Addendum 1 for RFB911700-01

Project Name: IVH-Courtyard

Addendum 1

PROJECT:
 9117.00
 IOWA VETERANS HOME
 COURTYARD DESIGN
 1301 SUMMIT STREET
 MARSHALLTOWN, IOWA 50158

DRAWING TITLE:
 PUTTING GREEN DETAILS

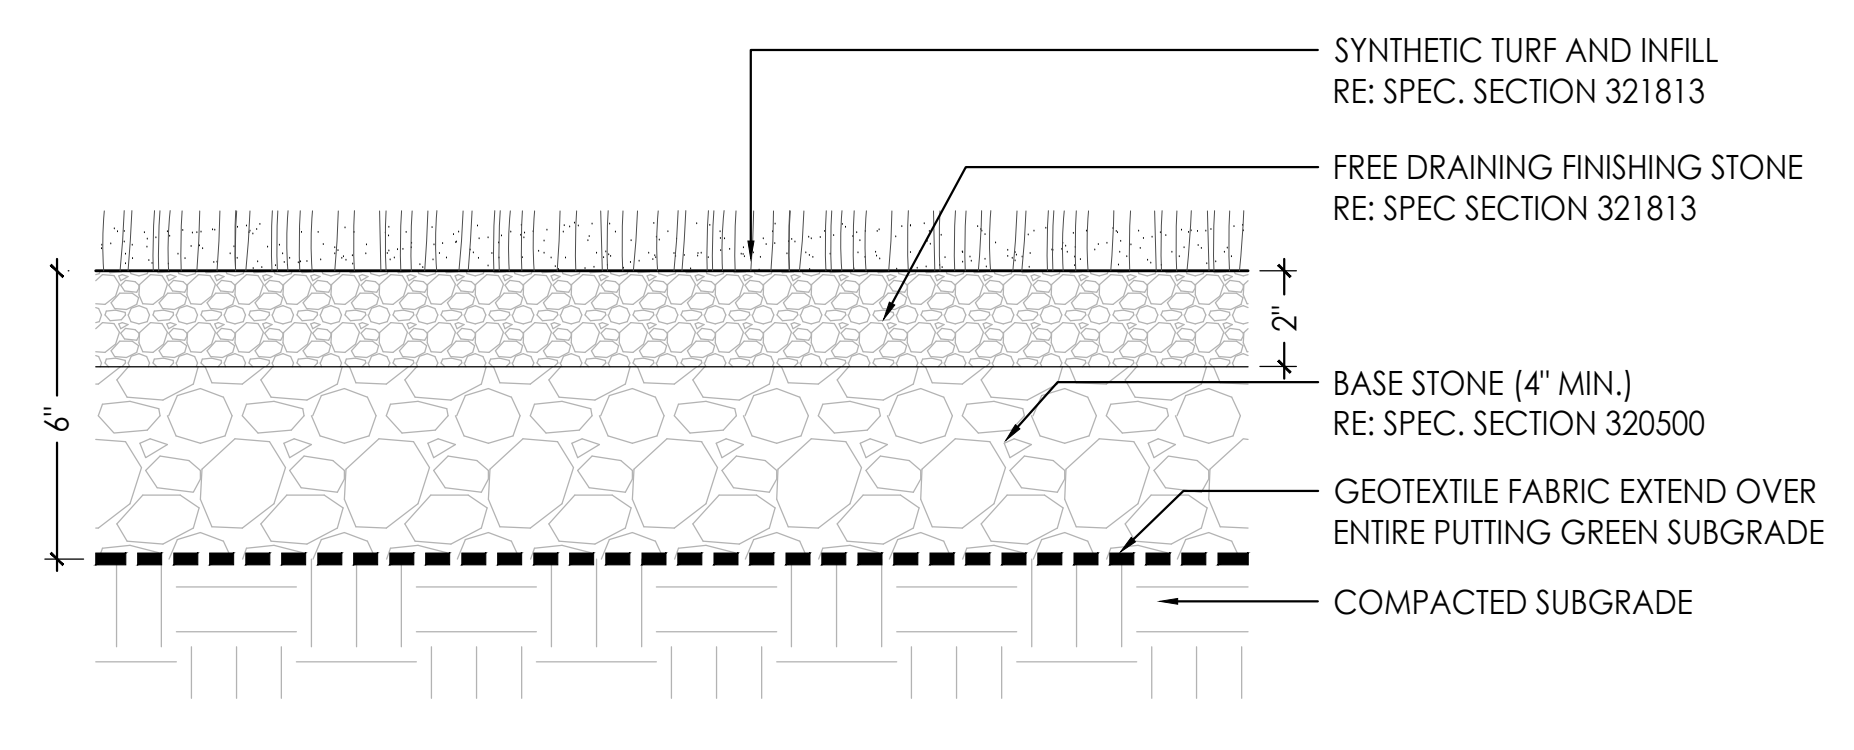
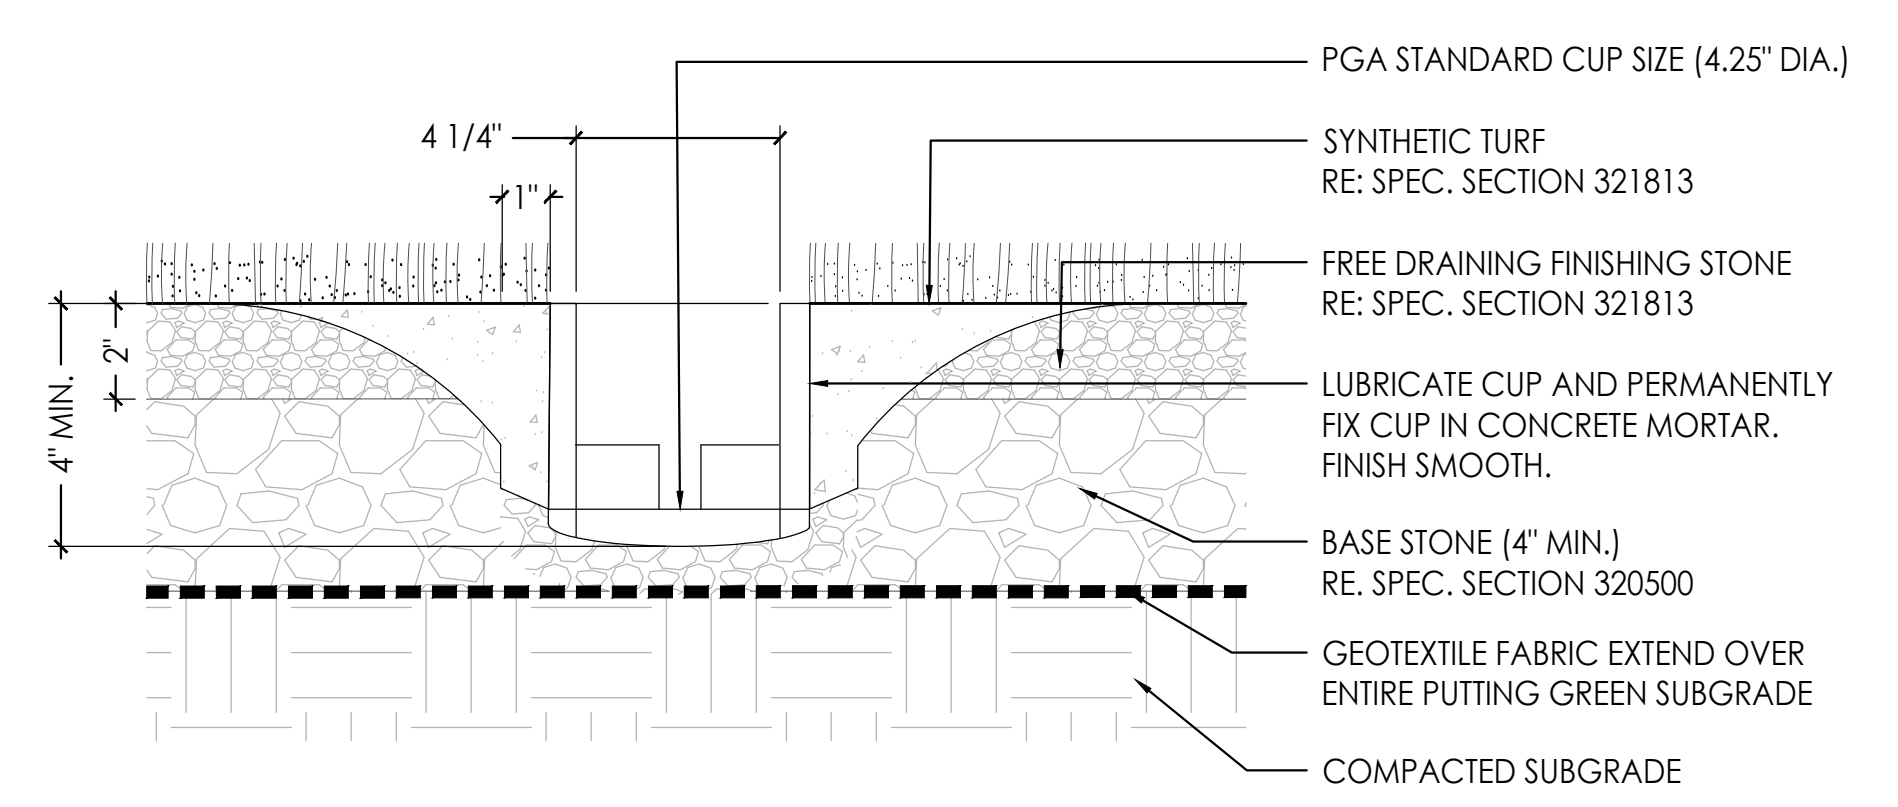
7. The base specifications are a little strange for how to build the green. It calls for 3/8" finish drainage stone.. This would make for a very bumpy putting surface. We use AB3 (aggregate with a layer of dust fines on top) to create the purest roll possible. This is not a permeable option either. All of our putting turf sheet drains anyways. How would you like me to proceed?

- a) The actual specifications (32 1813) do not specify the stone material, the details on sheet L808 do. There is a discrepancy between details 2, 3, and 4 on sheet L808. Detail 4 correctly calls out the stone base as 3/8" minus, which includes fines. The AB3 aggregate

appears to have stone larger than 3/8" which may be concerning. Permeability is desired in some regard otherwise water will pool in subtle depressions and along the edges of the perimeter concrete.

- Cover Page – Table of Contents and Clarifications (3 pages)
- Prebid Meeting Minutes (3 pages)
- Bid Form (7 pages)
- L803 SECURITY FENCING DETAILS (1 page)
 - The Ring adornment feature has been removed from the Cantilevered Gate only.
 - All fencing details have been updated to reflect the “Montage Plus” specifications.
- L808 PUTTING GREEN DETAILS (1 page)
 - Update Plan to include a 2’ wide Fringe material around the entire perimeter of the putting green.
 - Update all details to consistently label the ‘free draining finishing stone’ layer.

- SynLawn "Precision Putt" (Putting Green) and "Syntipede 243" (Fringe)
 - c) Add Paragraph 2.5.A:
 - FREE DRAINING FINISHING STONE LAYER
 - The free draining finishing stone later shall be a 3/8" minus with fines or a crushes aggregate that is permeable and shall be capable of being laser-graded to a smooth surface.
